Space Sweater Ltd. (Jogitala)

Shi-145/1, Jogitola, Joydebpur, Gazipur
(23.973670N, 90.405423E)
2nd July 2018

Observations

Foundation layout plan

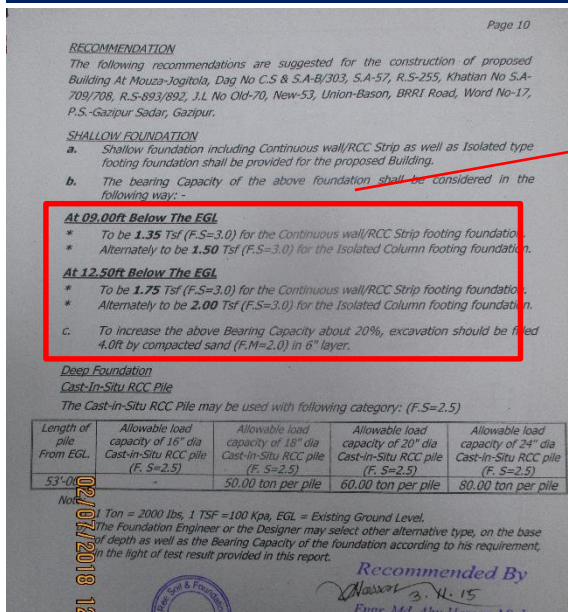
**Foundation to be stressed above normal
design limit**

Cursory calculation indicates that foundation appears to be stressed above normal design limits. Factor of safety (FoS) is less than the minimum requirement of BNBC. Factory engineer is required to review the adequacy of foundations considering actual depth and bearing capacity of footing and comply with BNBC.

Item No.	Observation	Recommended Action Plan	Recommended Timeline
1	(Production Building) Foundation to be stressed above normal design limit	Maintain 3kPa live load on typical floor and 2kPa on toilet zone.	6-weeks
2	(Production Building) Foundation to be stressed above normal design limit	Factory Engineer to review design, loads and footings stresses and a Detail Engineering Assessment to be completed.	6-weeks
3	(Production Building) Foundation to be stressed above normal design limit	Produce and actively manage a loading plan for all floor plates within the factory, giving consideration to floor, column and foundation capacity.	6-weeks
4	(Production Building) Foundation to be stressed above normal design limit	Complete implementation of remedial works deemed necessary by the review design.	6-months
5	(Production Building) Foundation to be stressed above normal design limit	Continue to implement loading plan.	6-months

Foundation Schedule

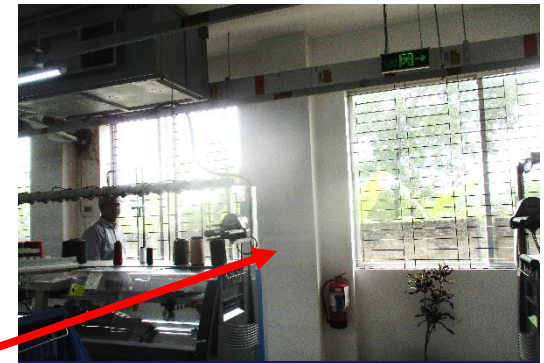
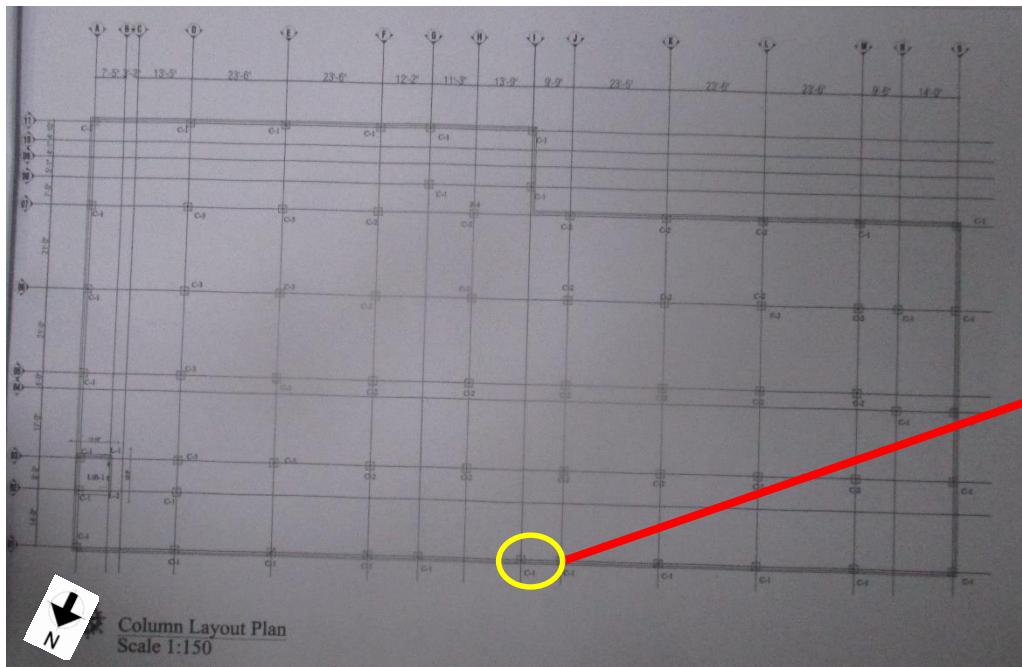
Recommended soil bearing capacity 1.5 Tsf for 9 ft. (2.74 m) depth, Considering FoS = 3

C-1 type column

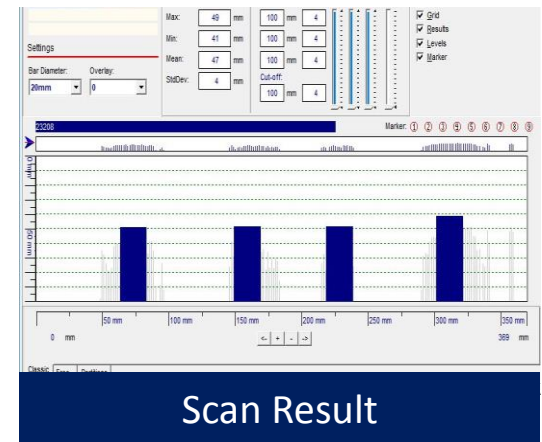
Number of rebar for C-1 column does not match with column schedule. 12 nos. of rebar were found by ferro scan whereas 16 nos. of rebars are shown in column schedule.

6	(Production Building) Discrepancies between provided drawings and on site condition	Building Engineer to confirm the number of rebar in columns and prepare accurate as-built survey information for the building.	6-weeks

Stagnant water on roof

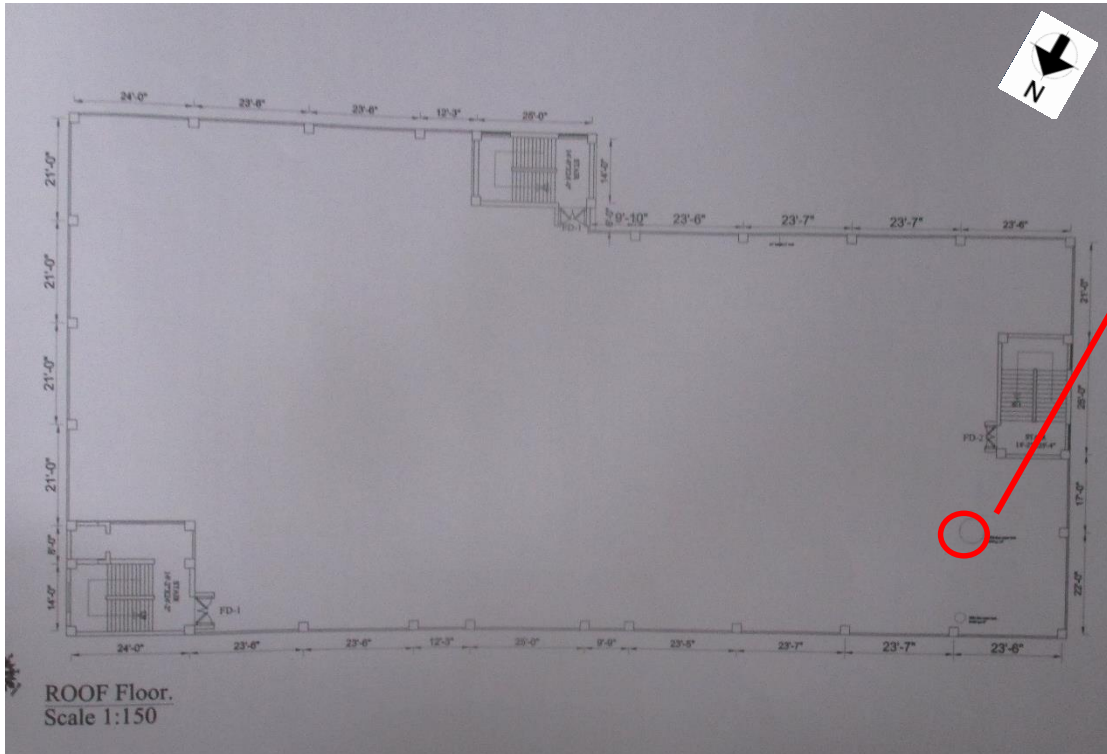
Water ponding was found at roof of the production building. Factory is required to improve water drainage system to avoid water clogging.

Item No.	Observation	Recommended Action Plan	Recommended Timeline
7	(Production Building) Water ponding on roof	Factory is required to provide water proofing layer and improve water drainage system to avoid water clogging.	6-weeks
8	(Production Building) Heavy water tank on roof	Verify that supporting structures have adequate capacity to support heavy loading such as (10,000 liters) plastic water tank.	6-weeks
9	(Production Building) Heavy water tank on roof	Remedial works to be carried out if required.	6-months
10	(All ancillary buildings) No structural drawings for ancillary buildings	Prepare an “as constructed” drawings which reflect the actual site dimensions with complete structural information.	6-weeks
11	(Utility Building) Expose rebar and falling hazard risk at roof	All exposed reinforcement is to be protected from corrosion which may cause degradation of the concrete.	6-weeks
12	(Utility Building) Expose rebar and falling hazard risk at roof	Provide periphery railing/parapet wall to avoid possible falling hazard.	6-weeks

Roof Plan

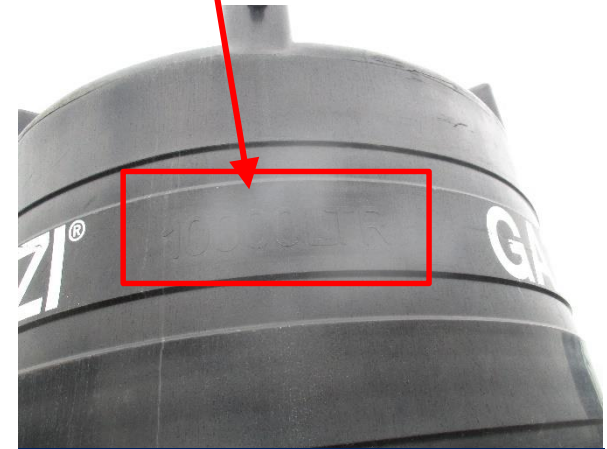
Over head plastic water tank having 10,000 & 5000 liters capacity was found at west side of roof

**Observations: Utility Building, Fire Pump Room
Medical & Day Care Building and Gas Cylinder Room**

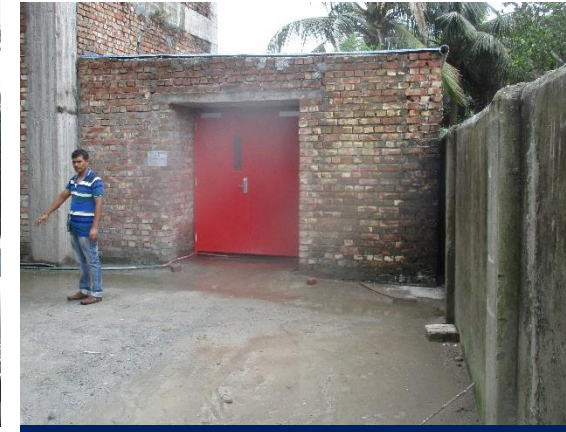
Structural drawings are not prepared for ancillary structures.
